**COMMISSION OF ARCHITECTURAL REVIEW
STAFF REPORT
March 27, 2018, Meeting**

4. **COA-031705-2018** (Stonewall Construction)

**2404 East Clay Street
Union Hill Old and Historic District**

Rehabilitate front porch, replace front door, and paint the structure.

2404 East Clay Street (March 2018)

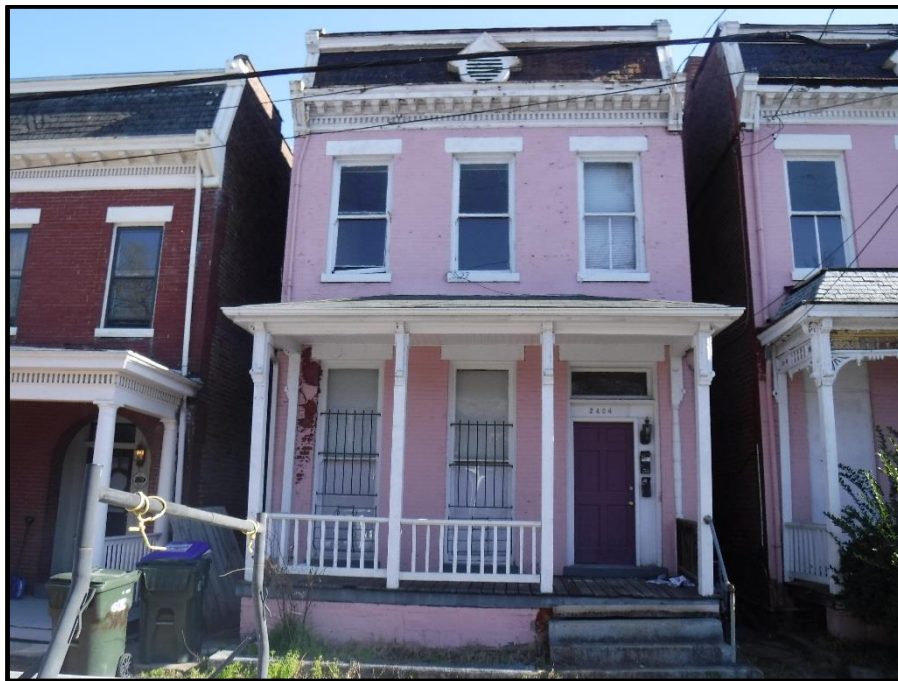
Porch: *The Richmond Old and Historic District Handbook and Design Review Guidelines* state available documentation including pictorial, historical or physical documentation should be used when reconstructing missing elements (pg. 59, #7). The proposed replacement roof matches the identical adjacent structure and is based on photographic evidence of the historic roof form. Staff supports the proposed design and materials for the new roof and encourages the applicant to consider restoring the spindle work frieze and sawn brackets as a part of this rehabilitation. Staff supports the replacement of the modern wood decking boards with wood tongue and groove decking boards as are found on historic properties in the district. The applicant has provided photographs of the historic spindle work balustrade on the adjacent property, and the adjacent property still possesses one surviving section of historic balustrade. Staff recommends a balustrade to match that of the historic balustrade at the adjacent identical property be installed on the porch rather than the proposed Richmond rail.

Front Door: Though staff has not located clear photographic evidence of the original front doors, staff supports the replacement of the modern front door, side lite, and panel with wooden double doors that will fit the existing opening as this composition is characteristic of historic structures in the district.

Painting: Staff has concerns that the proposed paint scheme is not consistent with the Commission's *Guidelines* for paint (pgs. 62-65). The *Guidelines* note that the colors of natural brick to include reds, browns, and yellow-clay colors are appropriate for previously painted masonry structure and discourage painting previously painted masonry structures blue (pgs. 63 & 65). The *Guidelines* also note that metal roofs should be painted blacks, greens, and reds, not the proposed light blue. In addition to concerns about the colors chosen for specific elements, staff has concerns about the number of colors to be used on the structure. The *Guidelines* note that the number of colors used on a structure should be limited to two to three colors (pg. 63, #4). For these reasons, staff recommends denial of the proposed paint scheme and recommends the applicant submit a revised paint scheme to staff consistent with the Guidelines for administrative review and approval.

Staff recommends partial approval of the project with conditions.
